Groundwater Application Review Summary Form

Application # G- <u>18862</u>	
GW ReviewerKarl Wozniak	Date Review Completed:11/19/2019
Summary of GW Availability and Injury Review:	
[] Groundwater for the proposed use is either or amounts requested without injury to prior water capacity of the groundwater resource per Section	
Summary of Potential for Substantial Interferen	ce Review:
[There is the potential for substantial interfere	nce per Section C of the attached review form.
Summary of Well Construction Assessment:	
[] The well does not appear to meet current well review form. Route through Well Construction a $\frac{1}{2}$ where	Il construction standards per Section D of the attached nd Compliance Section.
	ed and should be read thoroughly to understand the
basis for determinations and for conditions that r	may be necessary for a permit (if one is issued).

Review of Water Right Application G-18862

Application G-18862

Water-Level Trends in Nearby Wells

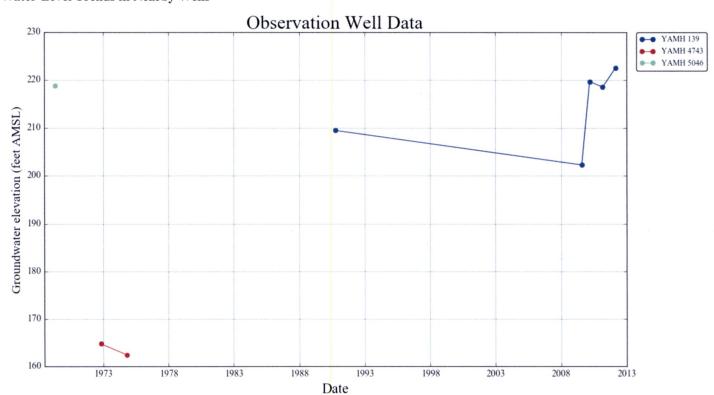
Water-level trends cannot be confidently evaluated because groundwater-level data is sparse in the general area (see plot below). There are no irrigation wells on active water rights within a mile radius. Tax lot density is relatively low and the OWRD well log database only shows records of about 125 domestic wells in the four adjacent sections.
